CITY OF TAYLOR, TEXAS

PLANNING AND ZONING COMMISSION MEETING

May 10, 2022, 6:00 P.M.

Staff has completed its review of plat for the RCR-Taylor Logistics Park Phases 1, 2 & 3 Preliminary Plat that is to be located at 201 FM 3349, Taylor, TX 76574. There are some corrections that need to be made prior to approval of the preliminary plat. Your plat application will be placed on the May 10, 2022, agenda for the Planning and Zoning Commission meeting. Comments from this review follow.

THE RETREAT AT MALLARD PRELIMINARY PLAT

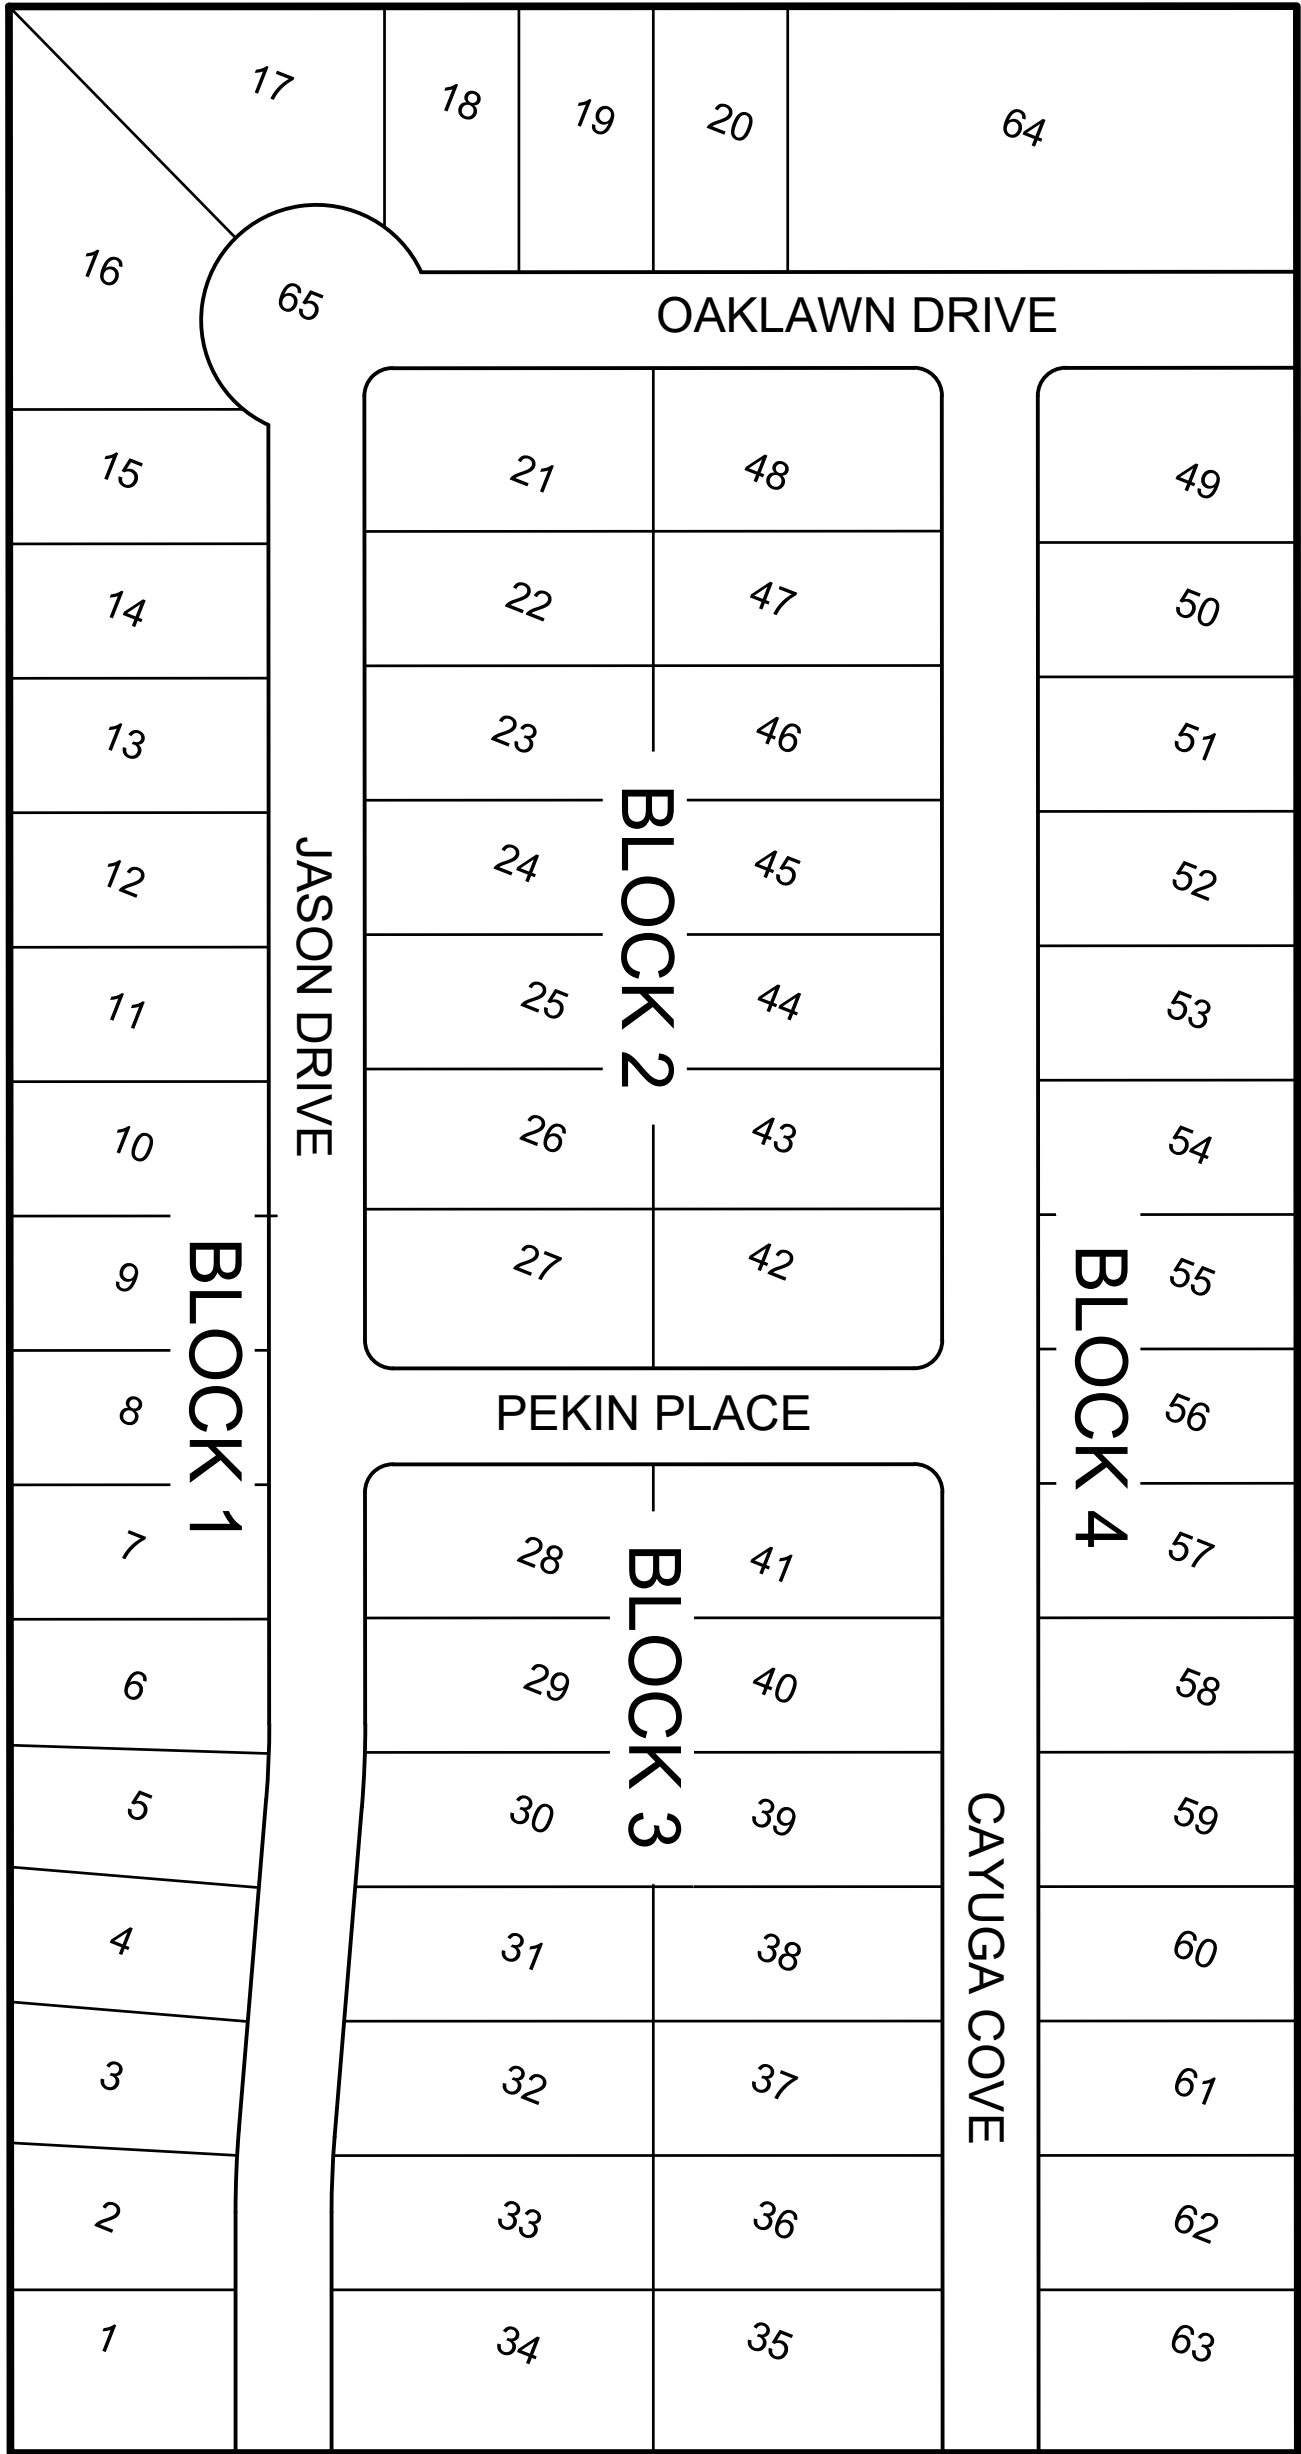
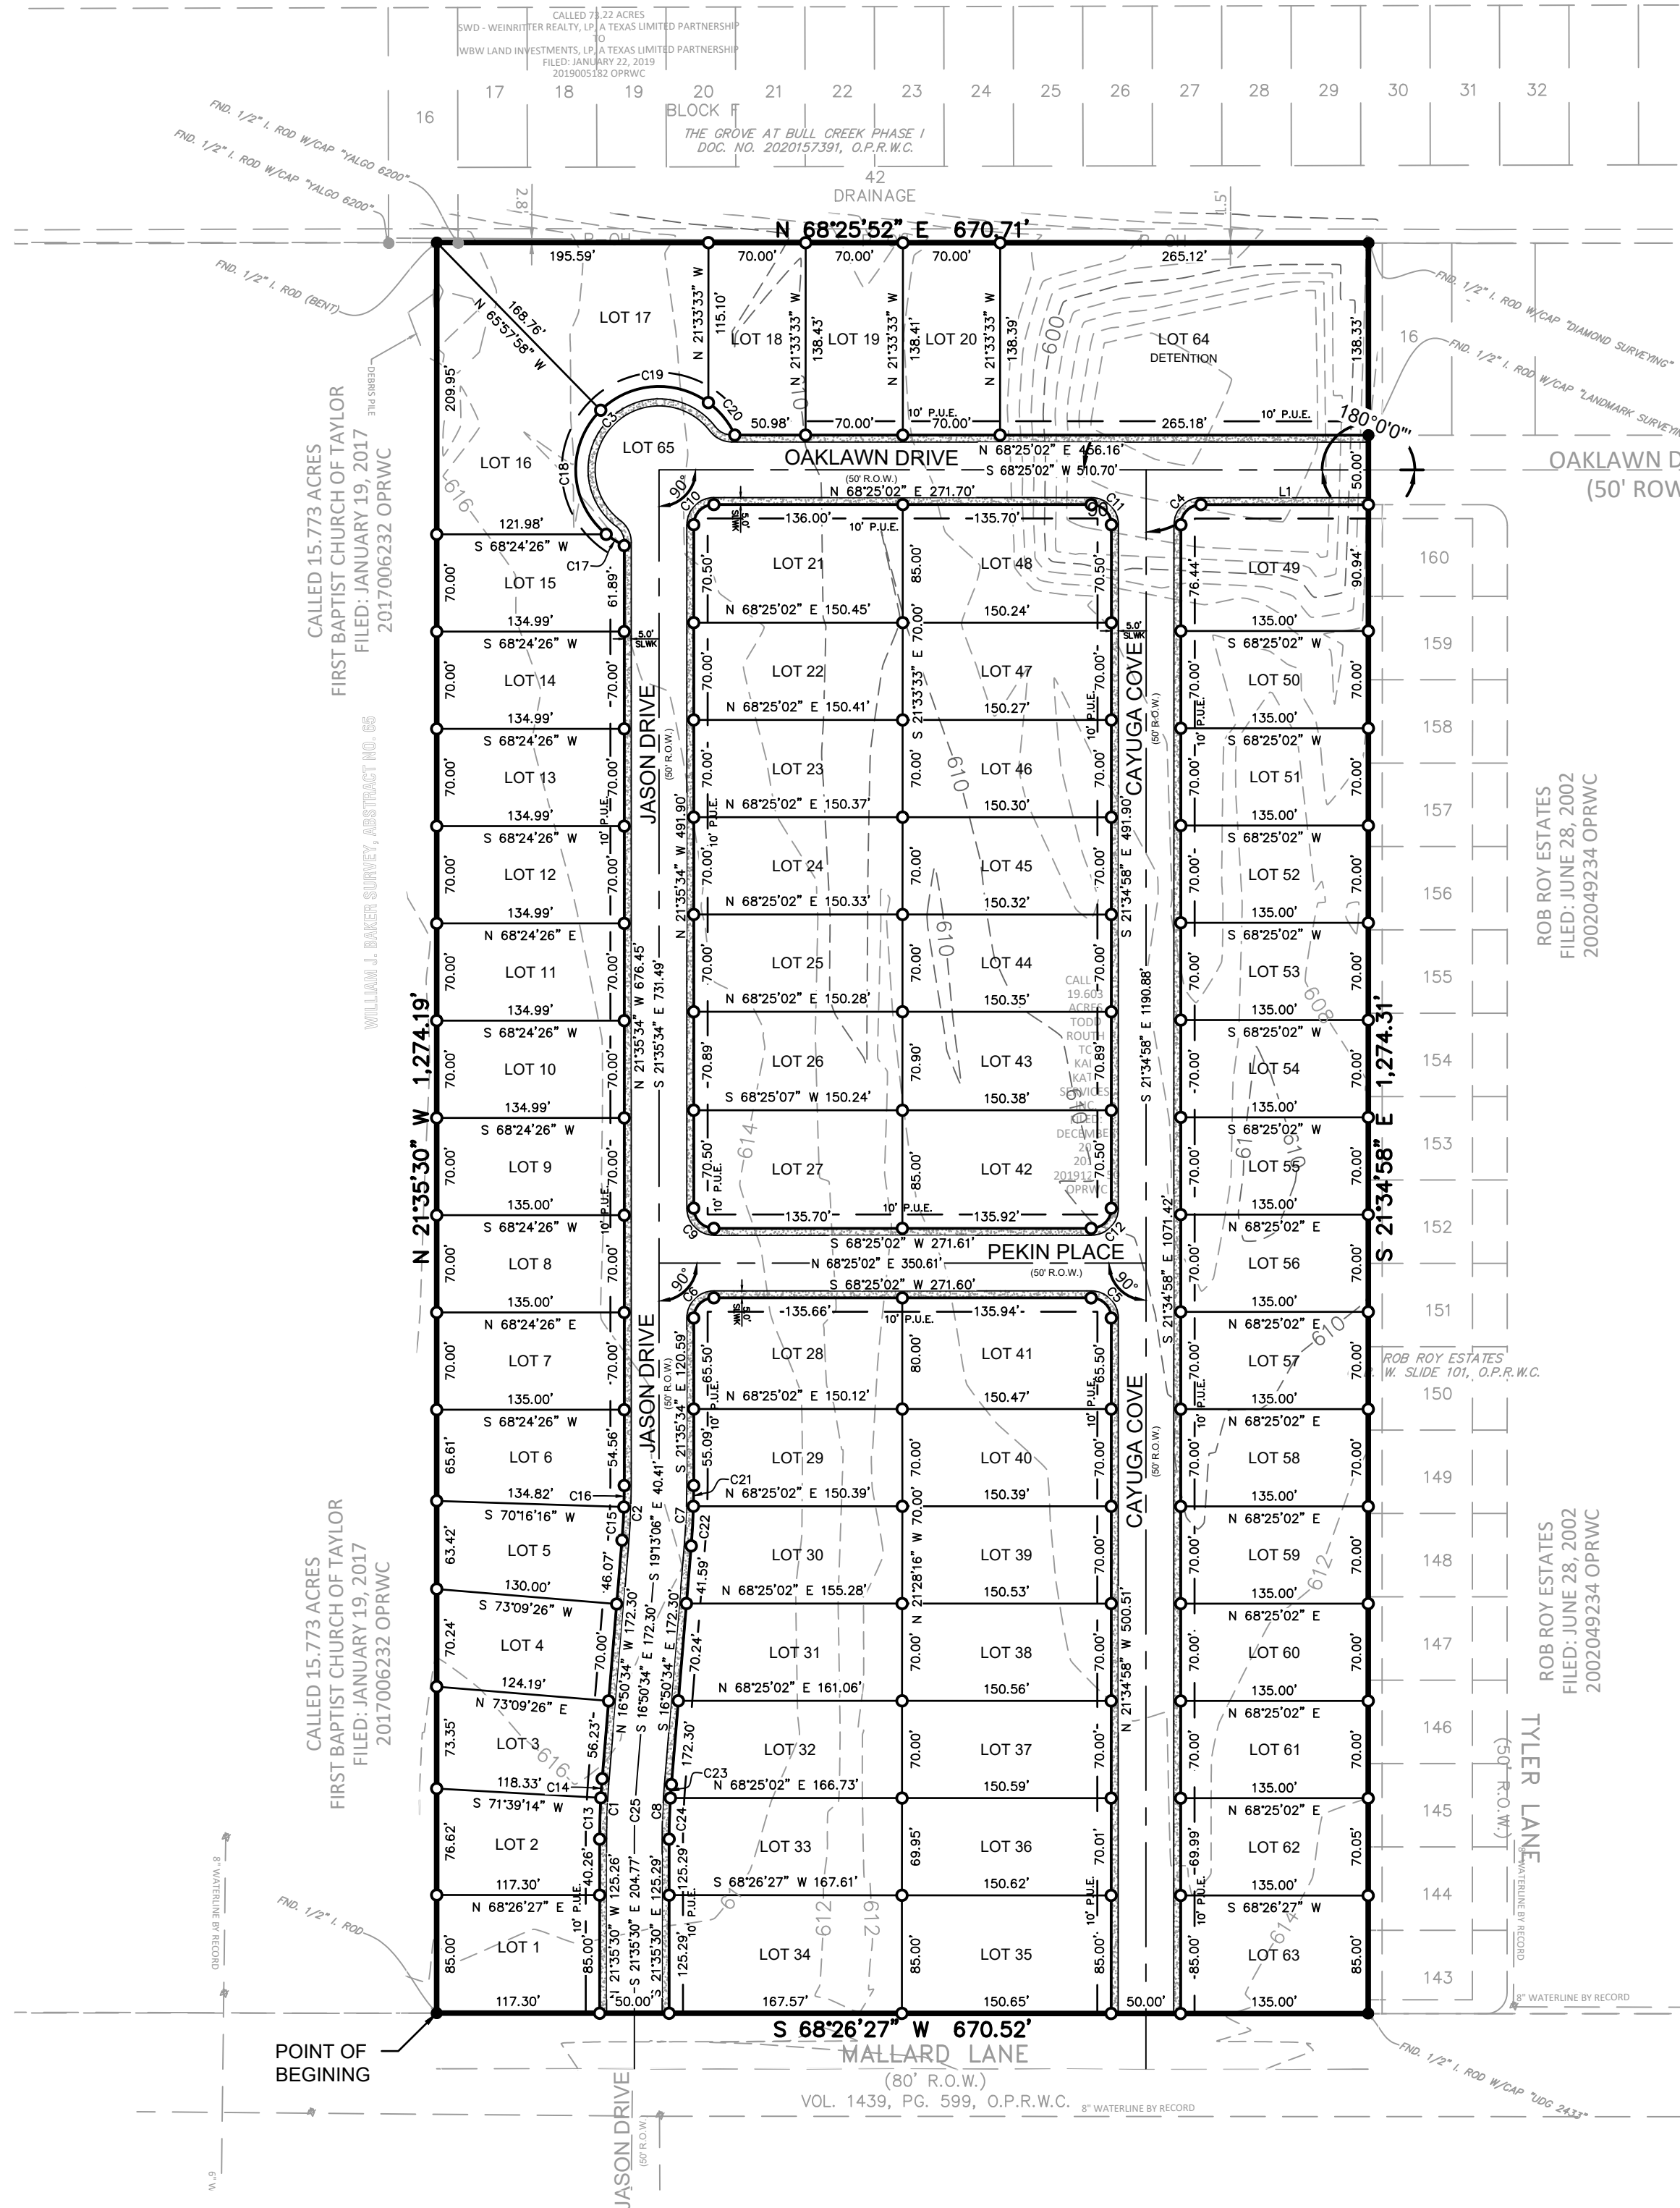
The plat map can be placed on the first sheet. There's no need for the duplicate on the first sheet that has no information other than the layout.

There's a lost graphic/label 65. It is out in the street. Remove it.

Add the square footage to the street's table. It may have to be moved to Sheet 2. All the tables are mostly too big. See below:

The detail showing the corner radii doesn't need to be on more than one sheet. Maybe it could be reduced. If something is unnecessary remove it. I don't even think you need the detail.

1. Show Scale bar text on the plat (e.g. 1"=100).

1. Show Scale bar text on the plat (e.g. 1"=100).
2. Provide a tie to an original corner of the original survey of which said land is a part (3.2 - Subdivision Preliminary Plat, 9c.)
3. Show subdivision information and lots on southside of Mallard Lane. Update Jason Drive shown.

1. Verify Note 12/13 shown and that drainage easements noted will be maintained privately.

1. All corner turning radii (c5, 6, 9, 10, 11, and c12) shall be a min. of 15 feet. The radii have changed from the previous submittal.
2. Plat shall note street names that are approved by Williamson County 9-1-1 addressing as noted in the Engineering comments.
